Revision to page 45 - Attachment L – Construction Procedures

Revision to Page 50 - Attachment M - Proposed Injection Wellbore Diagram

Revision to page 54 — Attachment Q-1 Proposed Post-Injection Plug and Abandon Wellbore Diagram

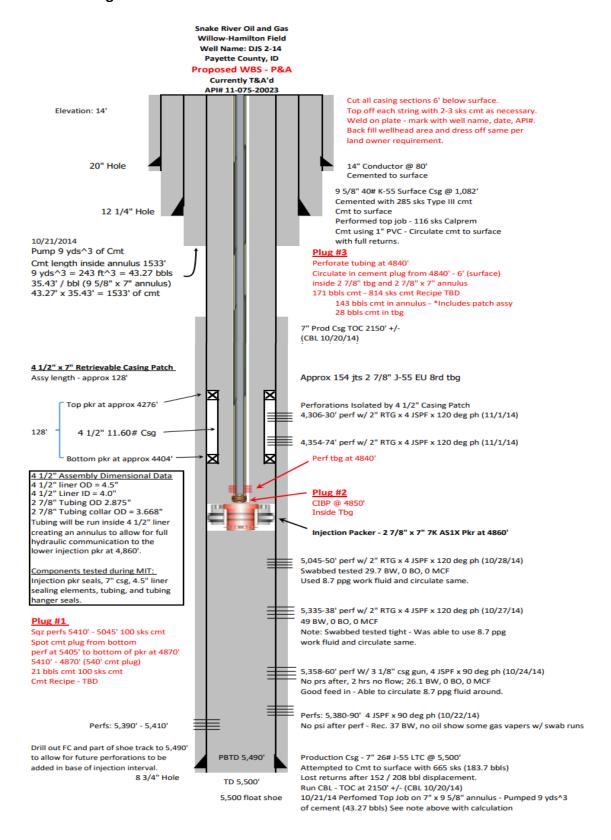
The proposed method for isolating the perforations that are above the Permitted Injection Interval (4,306'-4,330';4,354'-4,374') is a standard casing liner section / casing patch with respective casing packers above and below the perforations.

The assembly will consist of two (2) 4 $\frac{1}{2}$ "x 7" Casing packers and approx. 128' of standard API 4 $\frac{1}{2}$ "11.60# J-55 LTC casing which will be run across the perforations (4,306' – 4,330'; 4,354' – 4,374').

The lower packer will be set at approx. 4,404', with the upper packer set at approx. 4,276', with the $4 \frac{1}{2}$ " casing liner section connecting the two packers.

The perforations (4,306' - 4,330'; 4,354' - 4,374') will be isolated behind the 4 ½" casing and between the two casing packers.

The injection tubing string (2 7/8") will be run from surface, through the 4 ½" casing liner section, with the injection packer below the liner section at the proposed depth of 4,860', this will allow the injection tubing the ability to move freely inside the liner section as in any other completion. This downhole set up will provide the traditional and adequate tubing / casing annulus that will have full continuity from surface to the injection packer allowing for a true MIT operation. MIT's performed with this downhole set up will determine the integrity of multiple sealing areas consistent with standard MITs:
